# Milldale Fast-Track

**Specialist Response Template – Fast-track Approvals Act 2024 –  
Substantive Application**

**Technical Specialist Memo – Auckland Transport Traffic and roading matters**

Subject: Milldale Stage 4C and Stages 10 to 13 - Fast Track Application Transport Assessment

Figure 3: Eng drawing P24-128-00-2080-RD, showing five recreational bridges highlighted.

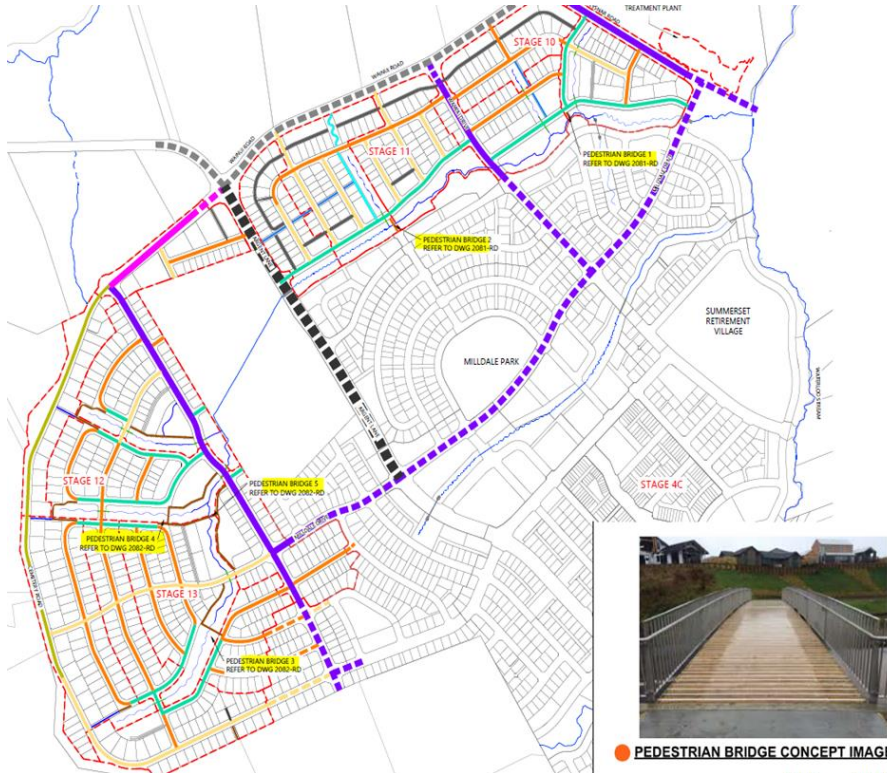
Auckland Transport has reviewed the bridges and has expressed openness to accepting Bridges 2, 3, and 4 as assets, as they can be considered road-to-road bridges serving a transport function, subject to the following conditions:

The Applicant must ensure that the bridges and their interfaces are designed in accordance with the Transport Design Manual (TDM); and

For any bridges with a dual function (e.g., Bridge 4, which includes a stormwater pipe), the responsibility for maintaining the utility must be clearly defined.

Auckland Council's Parks Planning team has confirmed that Bridge 1 will be accepted as a park's asset. Auckland Transport's has reviewed Bridge 5 and noted that it is not considered to have a road-to-road transport function. Therefore, Auckland Transport will not accept Bridge 5 as an asset.

- *On the scheme plan, bridges 2,3 and 4 must be shown as a "public accessway" so that they can be vested as an Auckland Transport asset.*
- *The consent holder is advised that the New Zealand Addressing Standard (AS/NZS 4819:2011) requires all new public roads and all extensions to existing roads to have a road name. A*

Figure 1: Excerpt from the Woods Civil Drawings showing T-intersections with side roads in close proximity to each other on Wainui Drive.

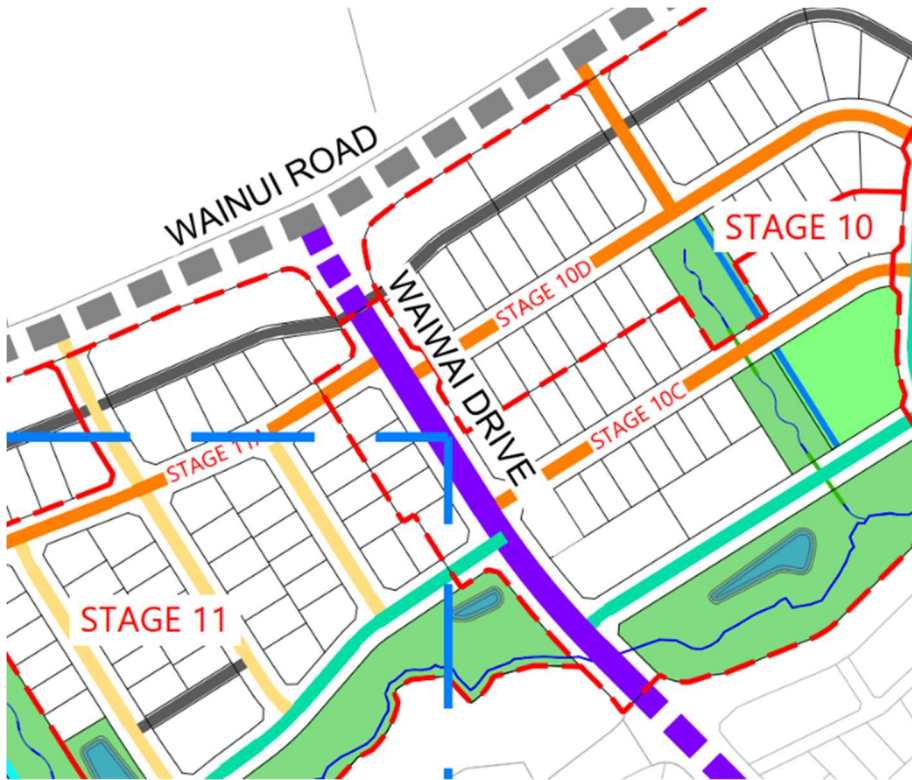
17. The proposed layout has T-intersections in close proximity to each other on Waiwai Drive between Stages 10 and 11 (refer to the excerpt from the Woods drawings in Figure 1 below). This creates potential issues with turning vehicles needing to use the same space which could have potential traffic safety and operational effects.

18. Bus stops are proposed close to the intersections on Waiwai Drive in positions which will limit sight distances for drivers turning out of nearby side roads when a bus is present. This will increase the risk of a crash at these intersections and constitutes a road safety effect. The applicant has provided additional comments on this matter, stating that it can be deferred to engineering approval stage for review. However at that stage boundary and intersection locations will be fixed and it is not clear if there are any suitable alternative locations for bus stops nearby which will not have either an impact on driver sight lines from intersections or would place bus stops too far from the dwellings they are intended to serve.

Figure 2: Excerpt from the Woods Civil Drawings showing T-intersections with side roads in close proximity to each other on Collector Road CR01

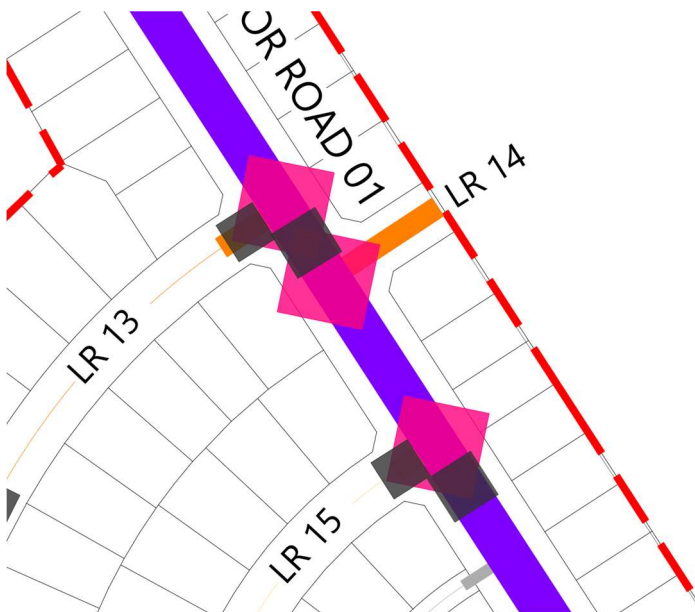
A similar concern exists on Collector Road 01 in Stage 12, where T-intersections are located too closely. Auckland Transport suggests relocating the eastern intersection one lot south to improve spacing and reduce potential conflicts.

19. A similar concern with intersection spacing also exists on Collector Road 01 in Stage 12 where T-intersections with side roads are also similarly closely spaced (refer Figure 2).

Figure 4: NoR8 drawings for the intersection of Dairy Flat Highway and Milldale Road.

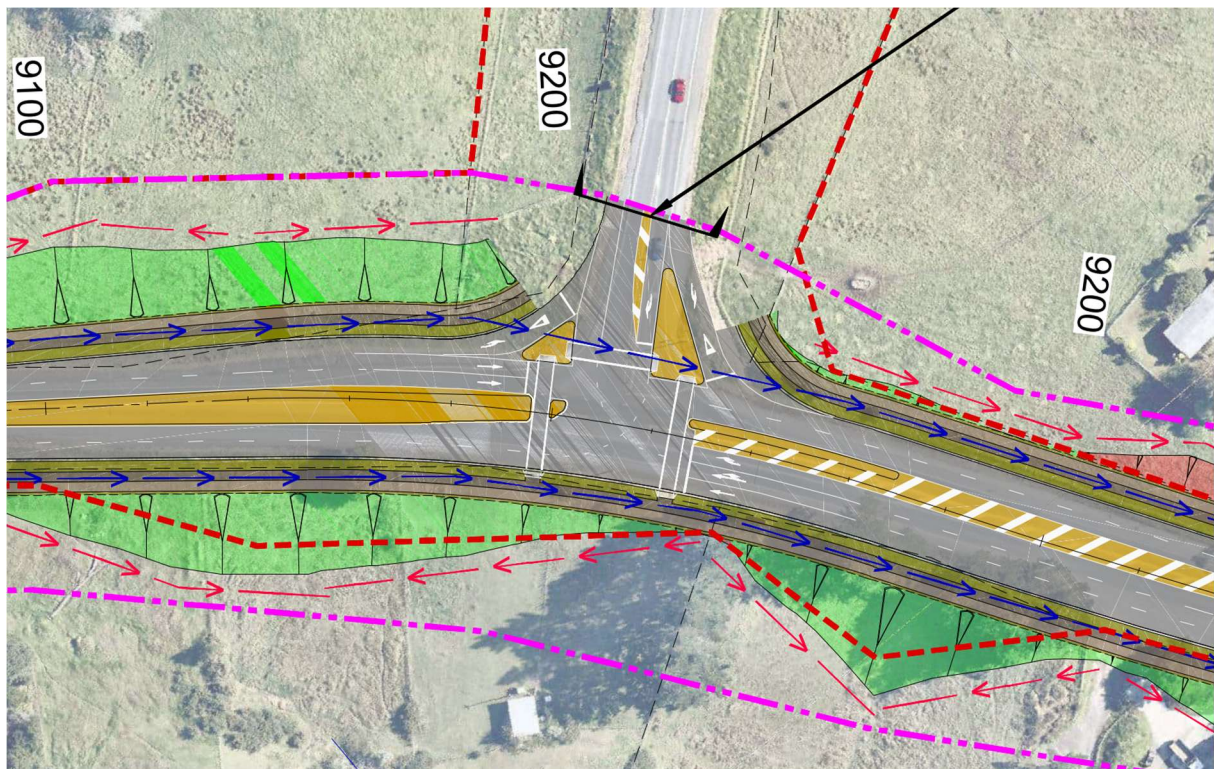
33. The principal differences between the two drawings are that compared to the Mott McDonald drawing the NoR8 drawing has only one lane for the left turn out of Pine Valley Road, no raised safety platforms are shown on the NoR8 drawing, no pedestrian crossing facilities are shown for the slip lanes, pedestrian and cyclist paths are shown on Dairy

Flat Highway, there is an extra westbound departure lane on Dairy Flat Highway west of the intersection and an extra shared right and through approach lane for Dairy Flat Highway east of the intersection.

Figure 5: Excerpt from the 2019 ITA showing the SIDRA layout diagram from the 2019 ITA

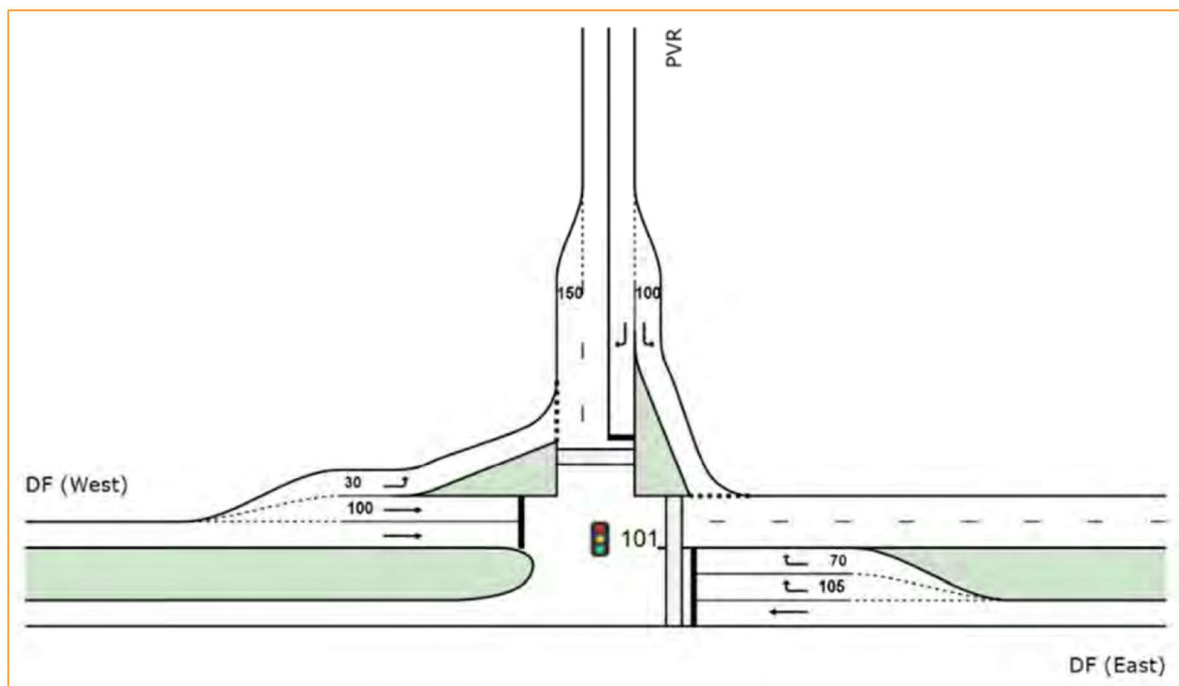
34. Figure 5 shows the SIDRA layout diagram from the 2019 ITA for the Pine Valley Road / Dairy Flat Highway Intersection. This has a different layout from both the NoR8 and Mott McDonald Drawings.
35. The three layouts differ in length of the auxiliary lanes, the number of left turn lanes out of Pine Valley Road, the number of approach and departure lanes, and in a number of more minor ways.

Figure 10: Excerpt from the NoR8 drawings showing an upgrade of the Silverdale Motorway Interchange.

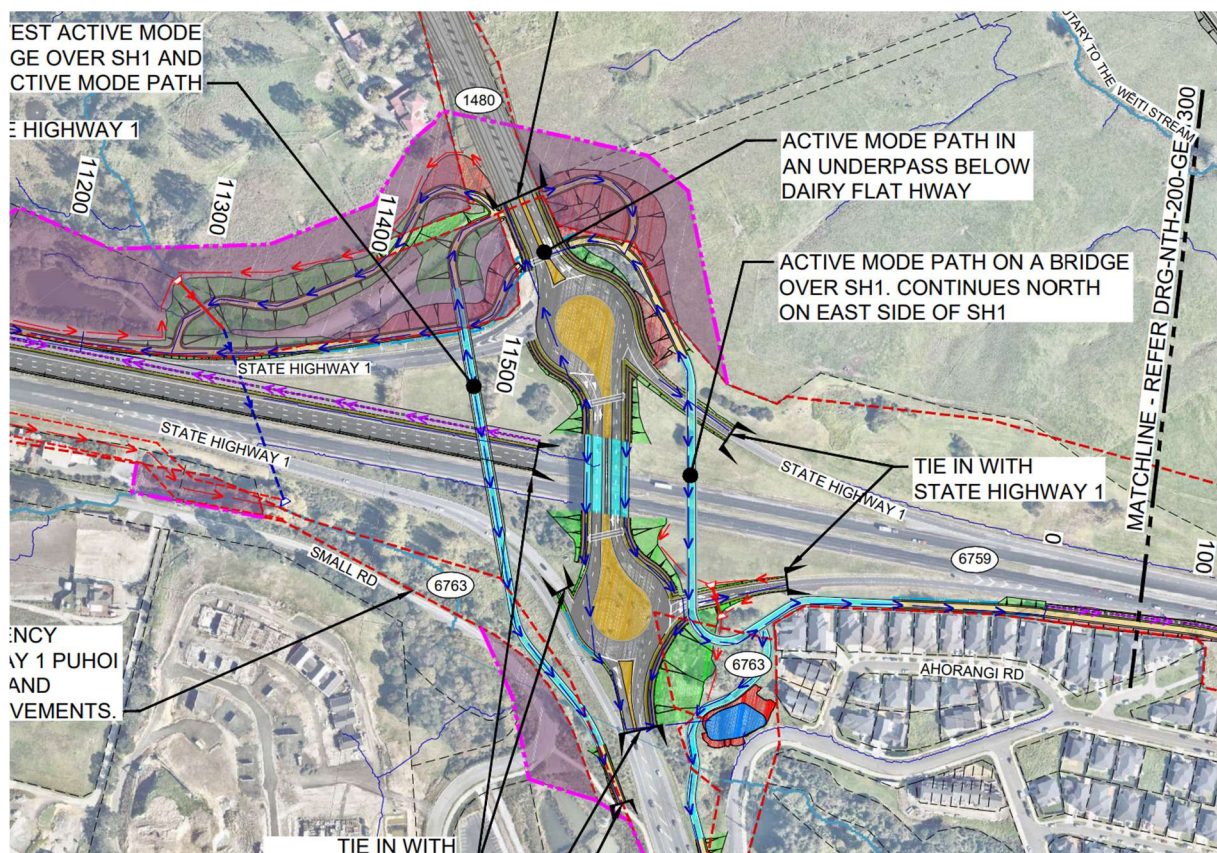
49. The NoR8 drawings for this area shows this in the form of two new active mode bridges crossing the motorway on either of the road bridge. This is shown in the excerpt from the NoR8 drawings below in Figure 10.
